CUSTOMER: STONE & WEBSTER ENGINEERING FOR RIVERHEAD STATION UNIT		REV.		DWN.		JOB NO.	
1	177	5	177	3-21-81	1-FWS-009	7908	
2	177	5	177	3-21-81	1-FWS-009	7908

BENJAMIN F. SHAW CO.
WILMINGTON, DELAWARE

FEED WATER

DRAWING NO.: 12210-009

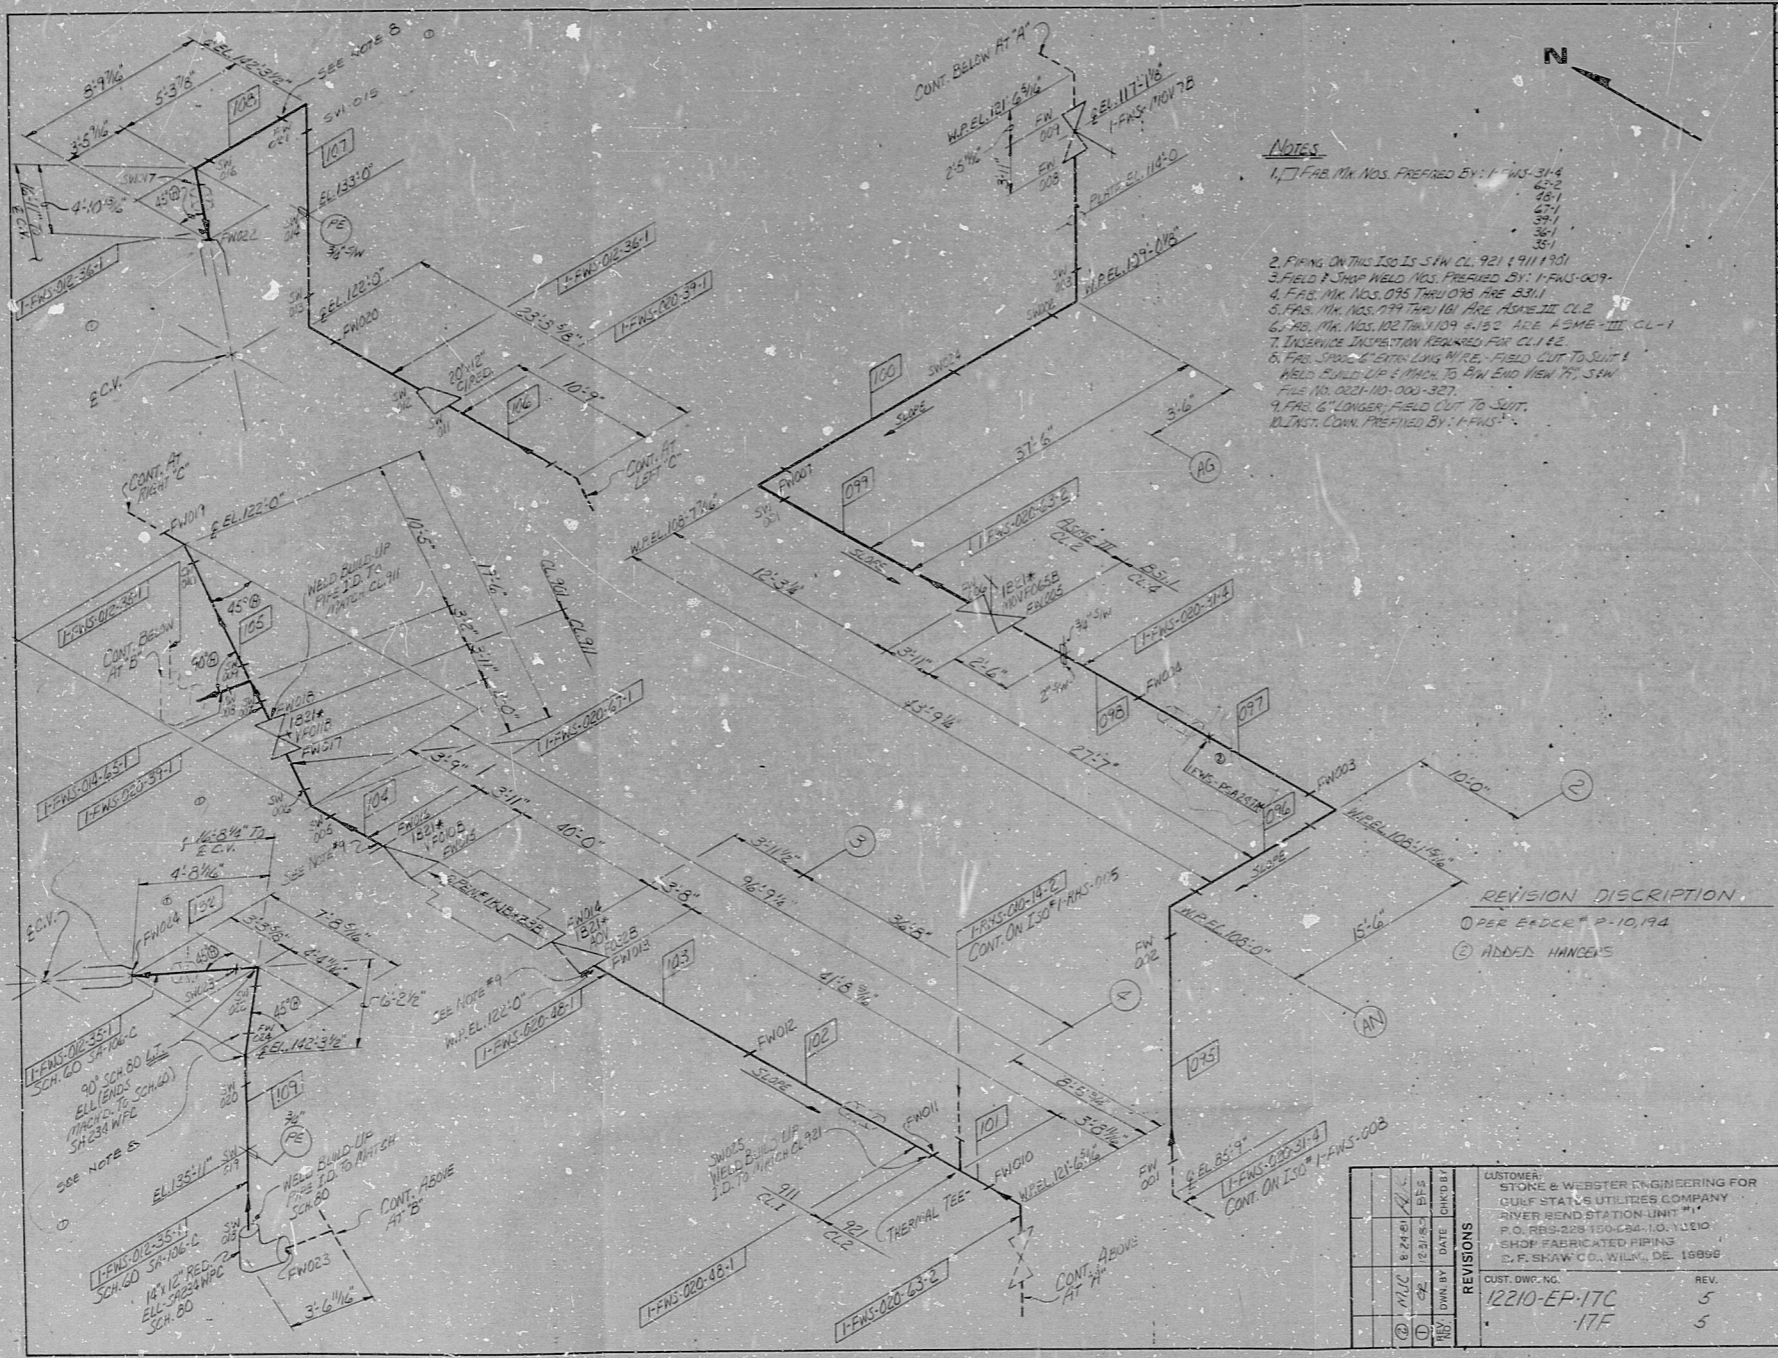
① PER EDGE P-10, 194

② ADDED HANGES
